August 19, 2019

Re: *PJM Interconnection, L.L.C., Docket No. ER19-2635 -000*  
*Amendment to ISA, SA No. 896; Queue Nos. D05 and K21 (amend)*

### Simplified One Line Diagram

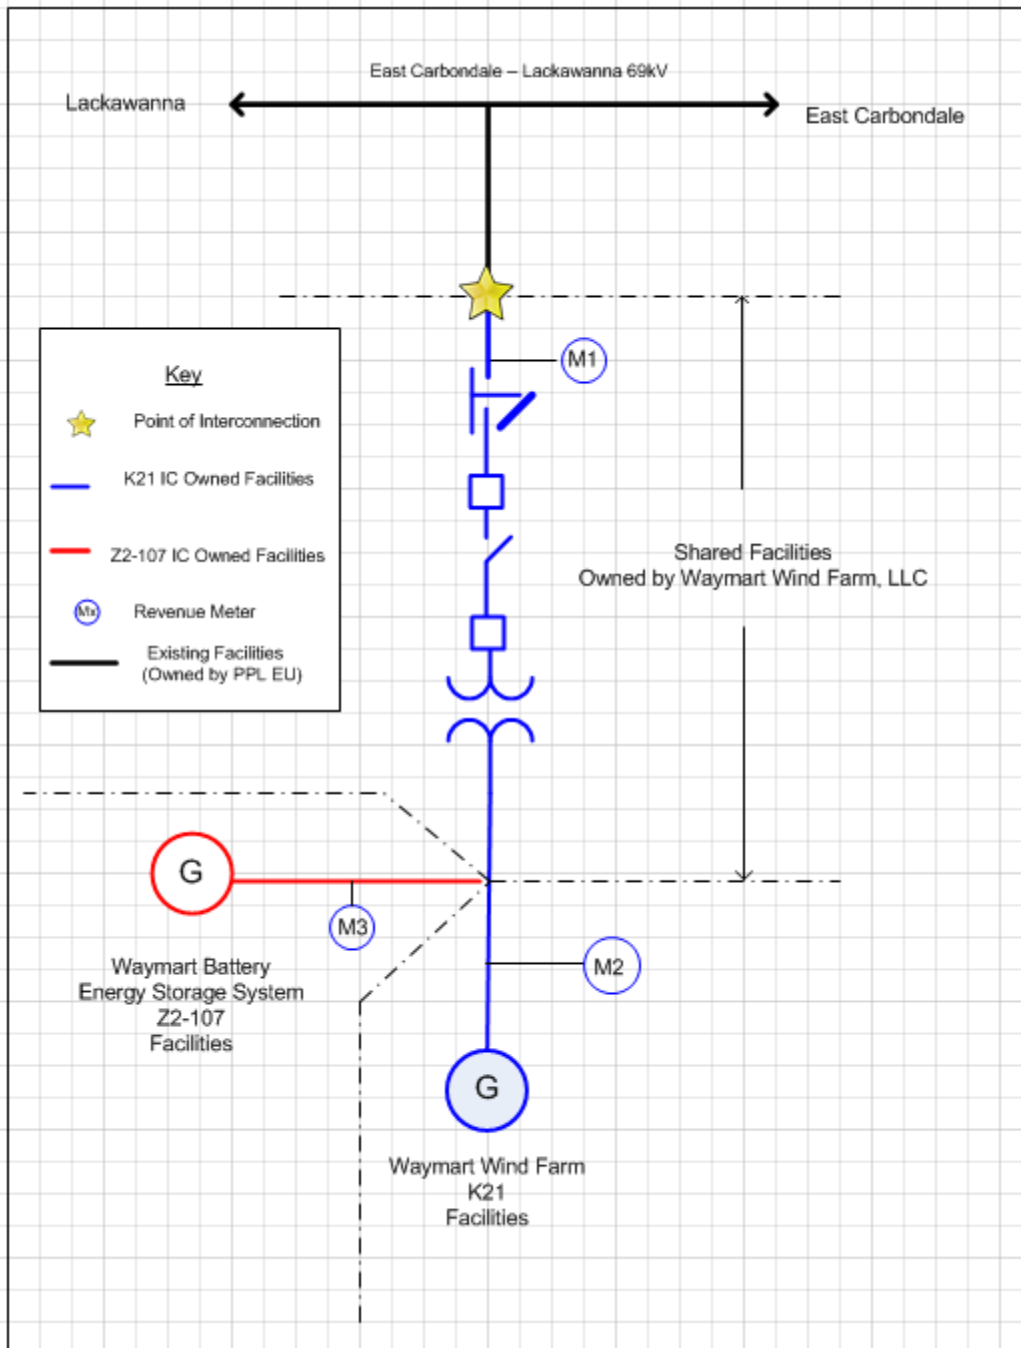
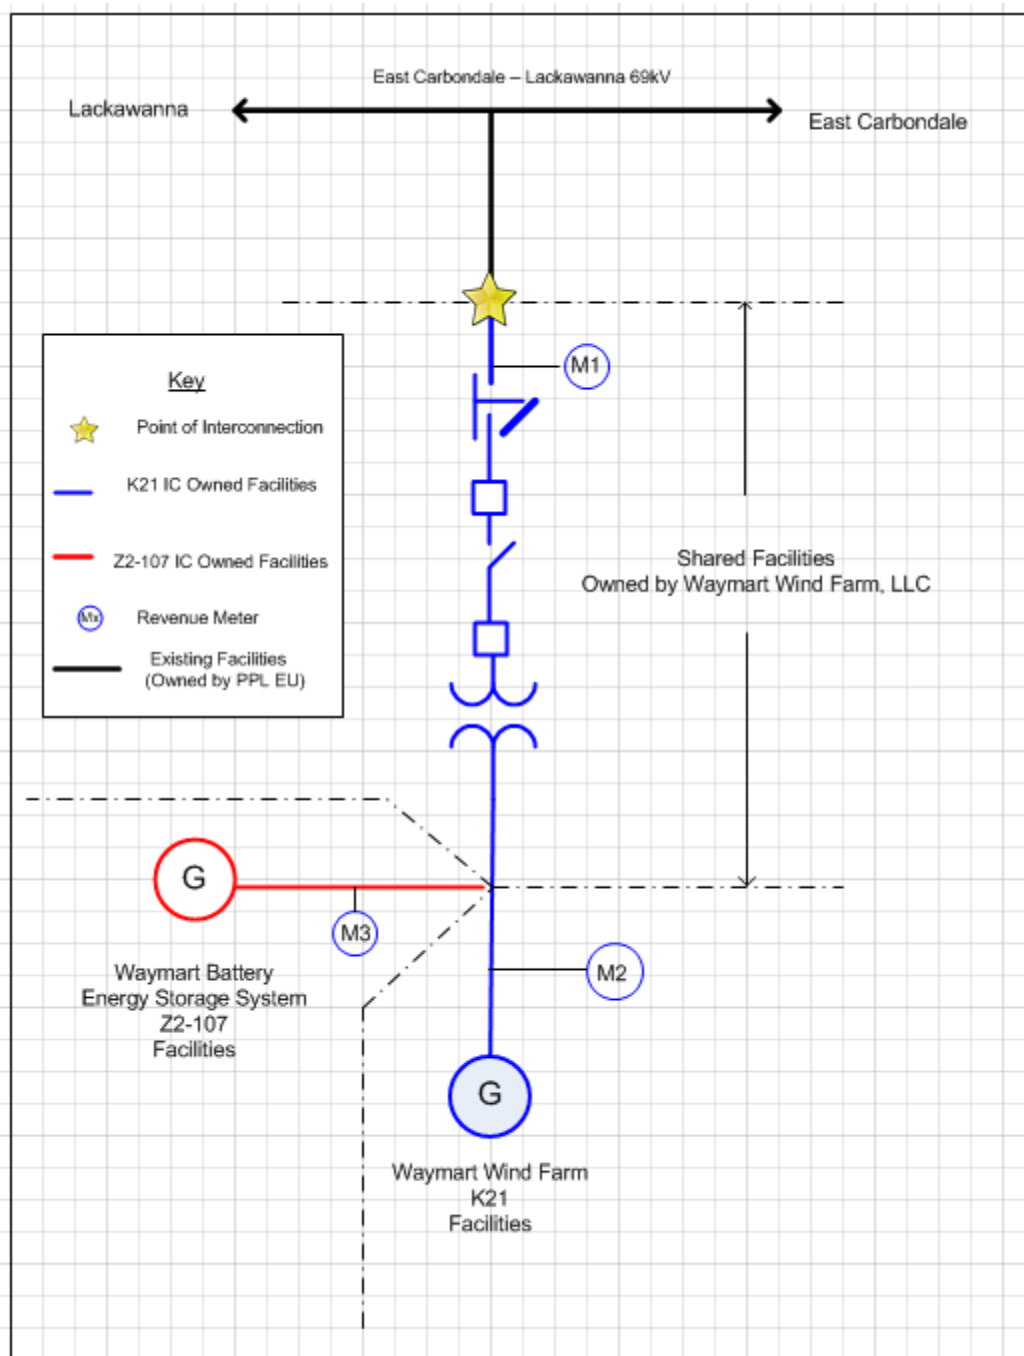
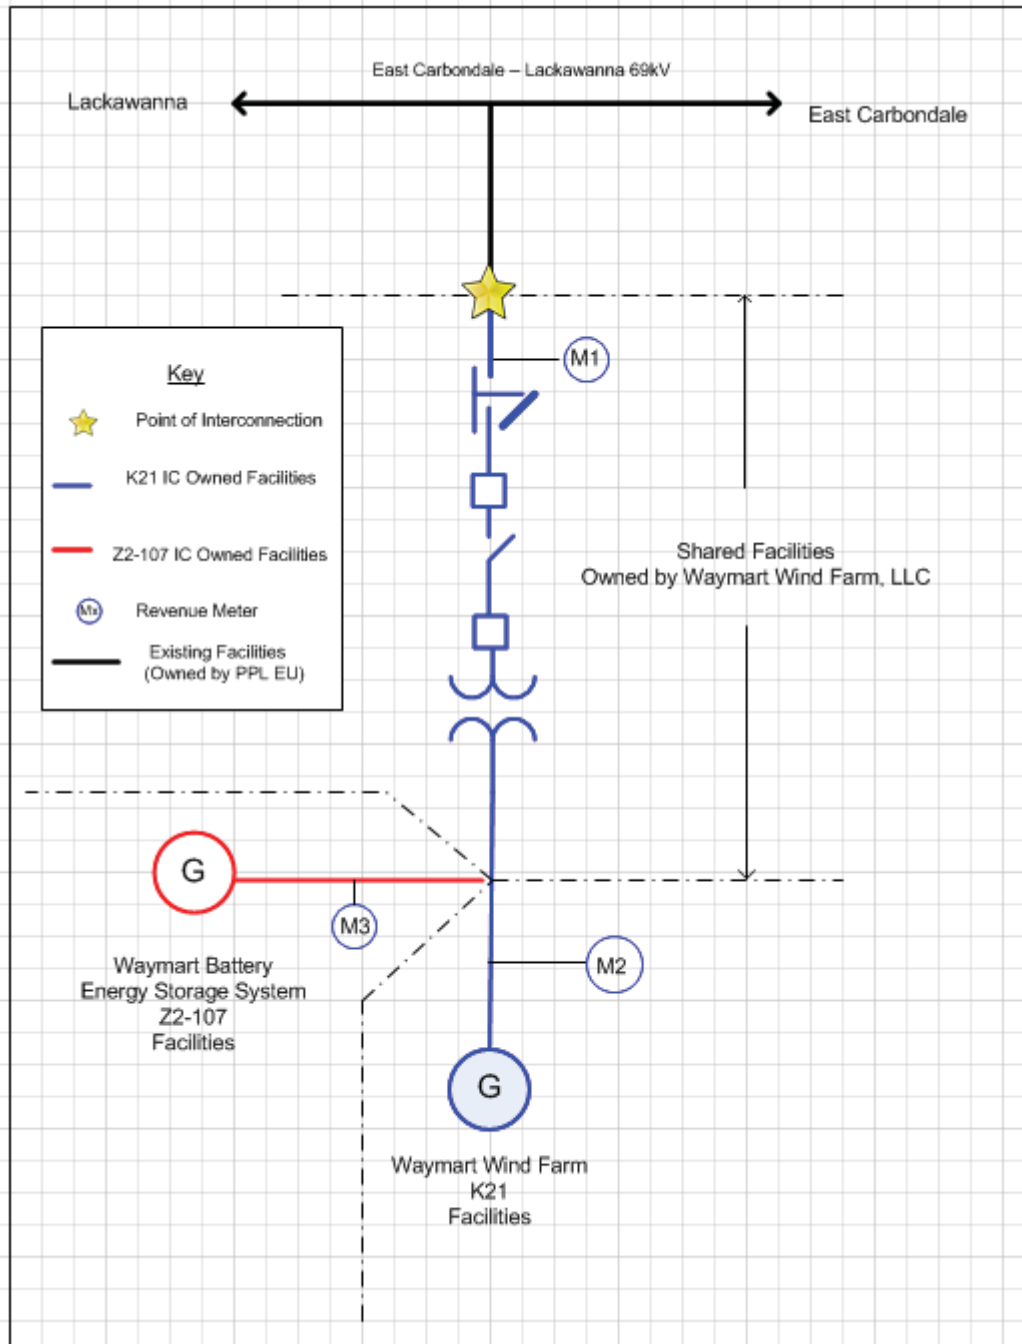
Schedule A, the Facility Location Site Plan, has been modified to reference Queue No. AD2-166. Schedule B, the Simplified One Line Diagram, was revised to reflect the current configuration and Interconnection Facilities associated with this ISA. Schedule D, the List of Metering Equipment has been modified to contain information describing the metering equipment to be owned by Waymart Wind and Waymart Storage. The last paragraph of Schedule D includes non-standard language stating that certain disputes related to settlement issues are to be resolved between the Waymart Parties. Schedule G has been revised to remove two sections (former sections 1.2 and 2) that are no longer necessary, and the remaining sections have been renumbered accordingly. Additional non-standard terms and conditions have been added to Schedule G related to the fact that there are two Interconnection Customers located behind the same Point of Interconnection. These non-standard provisions are discussed in more detail below. The execution page to the Amended Waymart Wind ISA has been revised to provide the execution date of the Agreement to Amend.
